ATTACHMENT 3

PROPOSED CHANGE TO TECHNICAL SPECIFICATION 3.4.9.3

ATTACHMENT 4

FIGURE 3.4-4

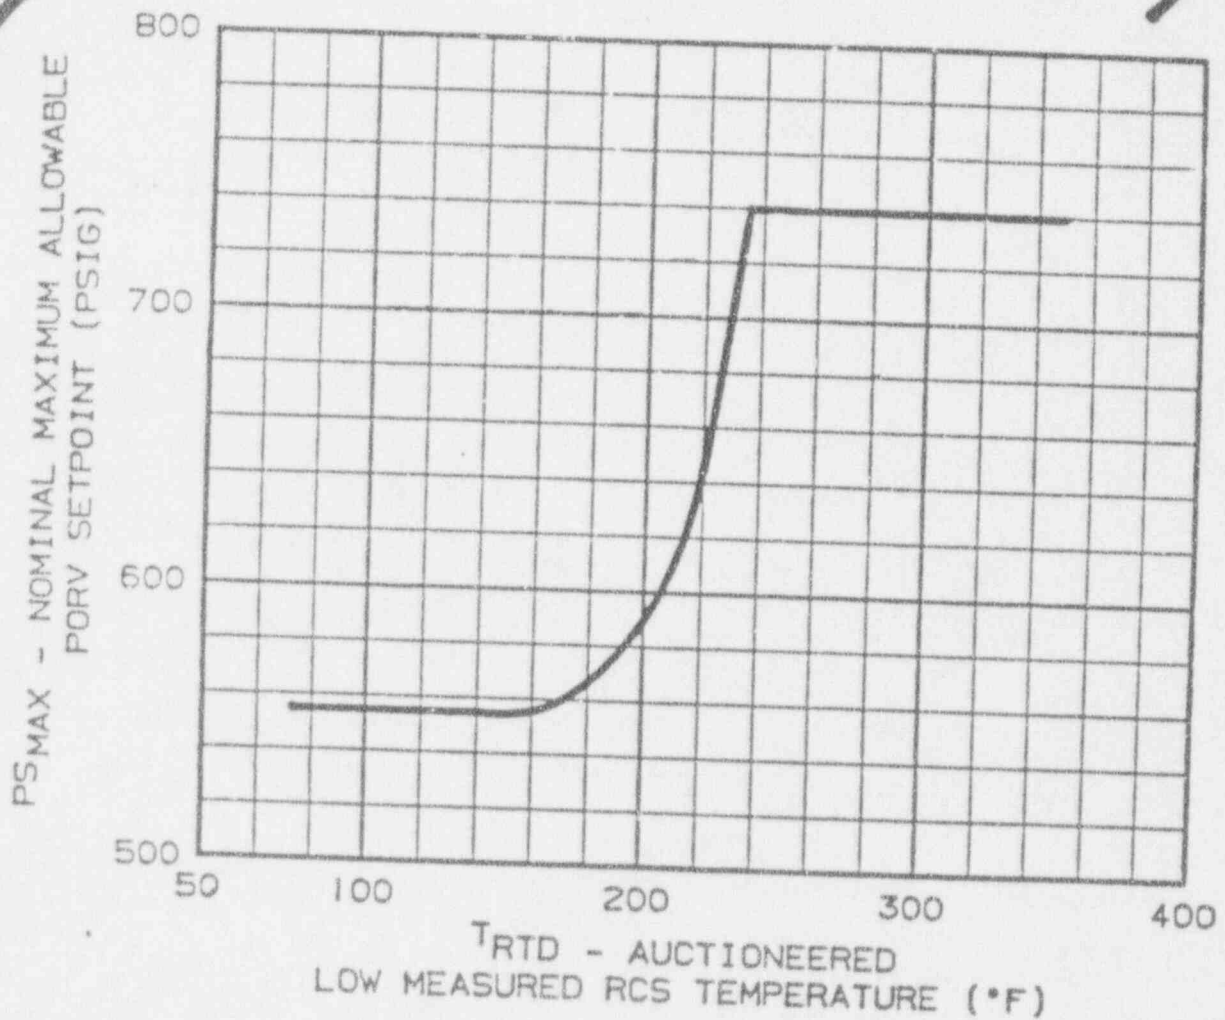
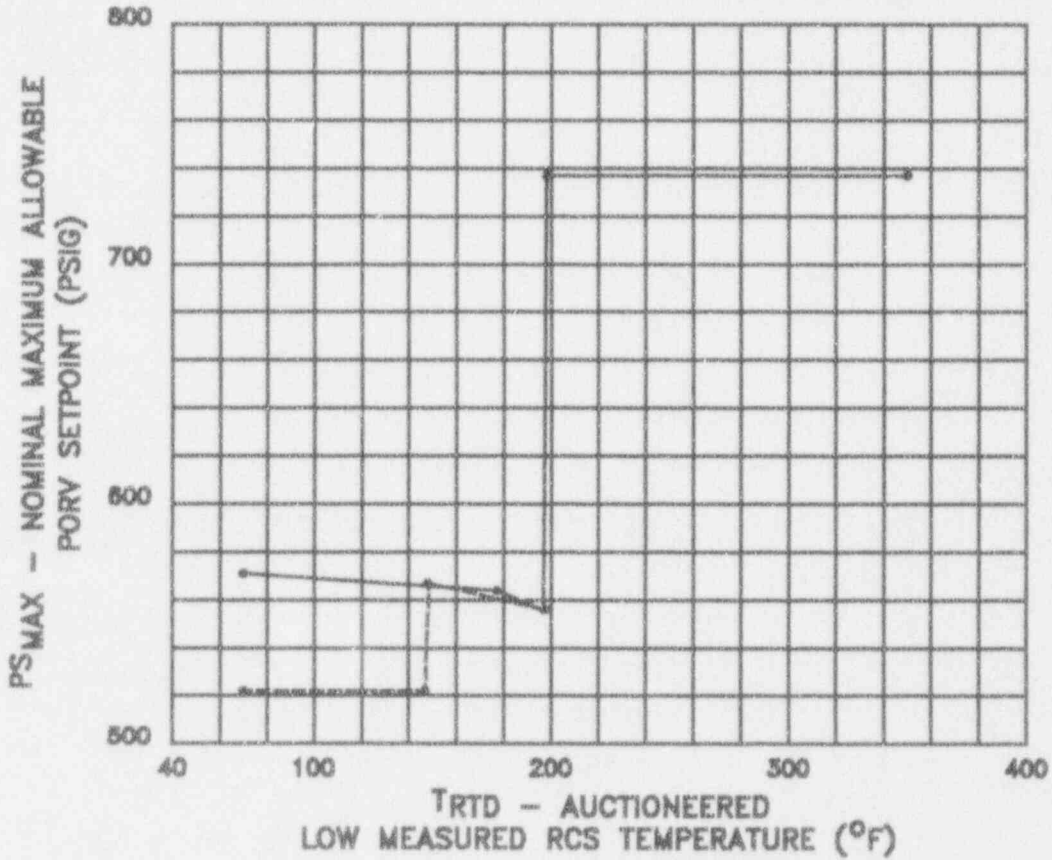
Replace with  
Attached.
